## **Service Bulletin**

Bulletin No.: 23-NA-082

Subject: Information for Vehicles Having Rear Park Assist Button But Rear Park Assist Does

Brand:	Model:	Model Year:		VIN Breakpoint:		Engine:	Transmission:	
Branu.		from	to	from	to	Eligilie.	Transmission.	
Chevrolet	Blazer	2023	2023	_	_	_	_

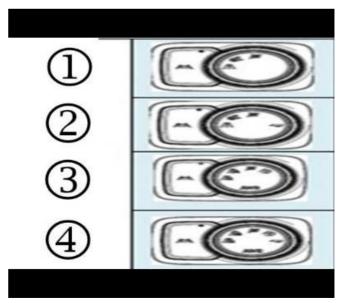
Involved Region or Country	Middle East, Israel, Chile, Colombia, Aruba, Cayman Islands, Costa Rica, Curacao, St Martin, Honduras, Nicaragua				
Additional Options (RPOs)	Equipped with PARK ASSIST-REAR, LANE ACTIVE SAFETY-KEEP ASSIST, DELETE CODE PARK ASSIST (RPOs UD7, UHX, 060)				
Condition	Some customers may comment on having a rear park assist button, but the rear park assist does not function.				
Cause	The condition is due to a design change to remove the rear park assist system completely with NO retrofit. The 2023 Blazer will never have a functional rear park assist system even though some vehicles were built with a ride control switch that still contains the rear park assist button on it.  Note: This button DOES NOT function and has NO effect on how the vehicle operates.				
Correction	If the customer desires to have the correct ride control switch without the rear park assist button, replace the ride control switch.

Remove the front floor console trim to remove the ride control switch. Refer to *Front Floor Console Trim Plate Replacement* in SI.
